**Planning Proposal to Rezone Lot 1 DP 700263, Lot C DP 160847, Lot 2 DP 629053 and Lot 3 DP 700263, 120-188 Hawkesbury Valley Way, Clarendon to B7 Business Park**

## Attachment A – Detailed Comments

**Planning Proposal**  
**Rezone 120 – 188 Hawkesbury Valley Way to B7 Business Park**

**Planning Proposal – 120-188 Hawkesbury Valley Way, Clarendon NSW 2756**

### George Street/Hawkesbury Valley Way

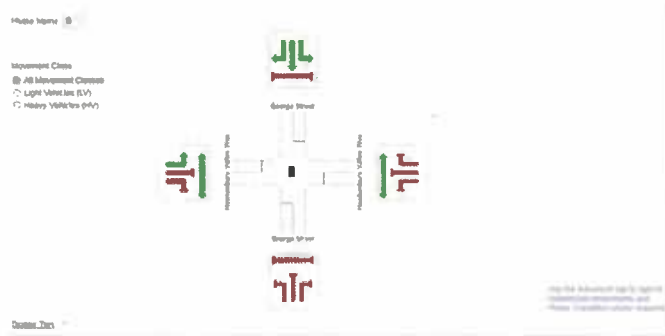
- 60km/h should be coded along Hawkesbury Valley Way.
- No heavy vehicles and default 0% grade were inputted for all scenarios.
- East leg of Hawkesbury Valley Way right turn length should be set at 40m. The taper length of 20m does not provide storage for a vehicle and would block the adjacent through lane.
- The site operates at 100 s cycle length during the peaks and should be applied for existing scenarios.
- The pedestrian movement priority should be turned on for all left turning movement in all scenarios.
- The B phase pedestrian movement should be turned off along Hawkesbury Valley Way West leg in all scenarios. See below:
